Work Order ID 128898

D3303-041 HEAD REST

DRAWING NO. D3303	TITLE HEAD REST	REV. B	DART AEROSPACE LTD ENGINEERING ORDER		D.E.O. NO. D3303-B-1	SHEET NO. SHEET 1 OF 1	SCALE NTS
DRAWN AJS	CHECKED <i>l</i>	MFG. APPR. <i>ll</i>	APPROVED <i>ll</i>		DE APPR. <i>ll</i>		
DATE 08.10.15	DATE <i>08.10.15</i>	DATE <i>08/10/16</i>	DATE <i>08/10/16</i>		DATE <i>08/10/16</i>

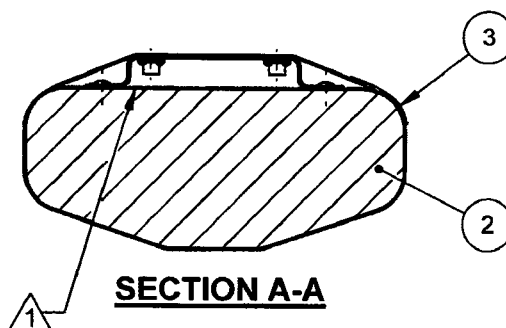
SHEET 1 ADD 1300L ADHESIVE BY 3M TO NOTE 1 AS FOLLOWS:

WAS:

NOTES:

- 1) BOND D3305-1 FOAM TO D3303-043 BRACKET ASSEMBLY USING 3M 1300 ADHESIVE (0.002" TO 0.010" THICK) IN ACCORDANCE WITH MANUFACTURER'S INSTRUCTIONS

SEE NCR 08-069 FOR FURTHER DETAILS

IS:

NOTES:

- 1) BOND D3305-1 FOAM TO D3303-043 BRACKET ASSEMBLY USING 3M 1300 OR 1300L ADHESIVE (0.002" TO 0.010" THICK) IN ACCORDANCE WITH MANUFACTURER'S INSTRUCTIONS
